**RESPONSE TO BRISBANE CITY COUNCIL FURTHER ADVICE – S.35 OF THE DA RULES  
CHANGE APPLICATION (MINOR CHANGE) PURSUANT TO SECTION 81 OF *PLANNING ACT 2016*, OVER LAND AT 208-220 GIVEN TERRACE, PADDINGTON**

**COUNCIL REFERENCE: A006909308**

# Further Advice Response

208 Given Terrace, Paddington

Figure 1: Extract of Approved Site Plan (A006476461) (Source: MAS, 2023)

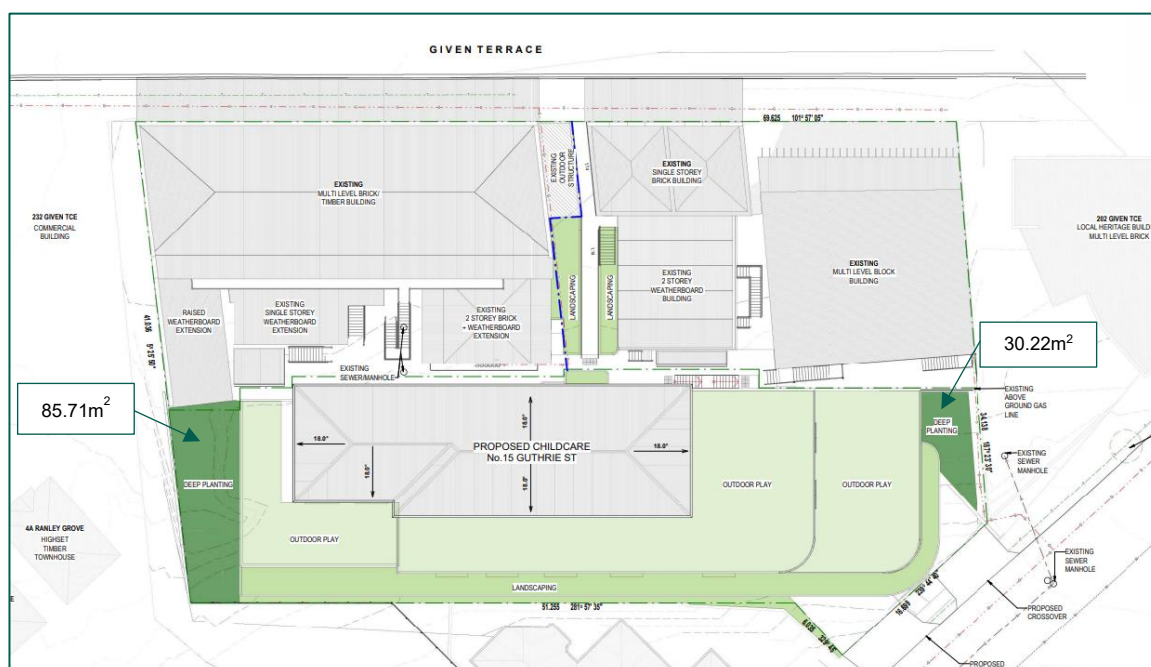
*The submitted town planning assessment indicates proposed deep planting of 31m<sup>2</sup> (or 2.4%). However, 31m<sup>2</sup> of the total site area (2,830m<sup>2</sup>) equates to 1.09% of the site area, or alternatively, if relating to only the development area (1,530m<sup>2</sup>) equates to 2.02% of the site area. Provide confirmation of the deep planting that is to be provided as part of the proposal.*

For clarification the 'development area' refers to the portion of the site which this application is subject to, meaning the short-term accommodation and multiple dwelling. The 'total site area' refers to the short-term accommodation, multiple dwelling and childcare.

A breakdown of the deep planting and landscaping components across the development area and site area is provided in **Table 2**.

For further clarity, DAH Architecture have confirmed the area of the deep planting as per the approval for the childcare centre plans. An extract of the approved plans with the confirmed areas are provided in **Figure 1**.

Figure 4: Extract of sections (Source: DAH Architecture, 2026)

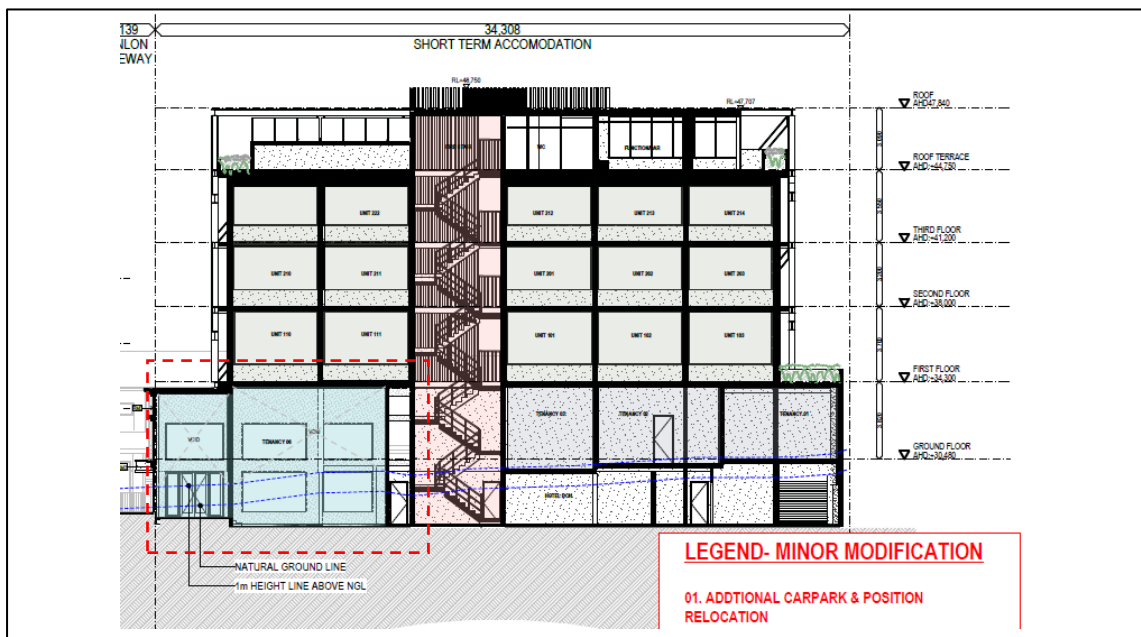
No changes are proposed to the approved height of the multiple dwelling component, while the relative level (RL) height of the short term accommodation is proposed to increase by 0.84m. However, the proposed plans indicate Tenancy 6 is located more than 1m above ground, and thus would be considered a storey per the Brisbane City Plan 2014 (City Plan) definition. Provide confirmation of the maximum building height in storeys for both the short-term accommodation and multiple dwelling components of the proposal per the City Plan definition.

Tenancy 6 within the short-term accommodation has undergone design improvements which ensure it does not increase the proposed number of storeys per the City Plan definition. As per Section 4, of **Attachment B**, Tenancy 6 provides a double height ceiling or 'void' space, to ensure that no additional storey is created.
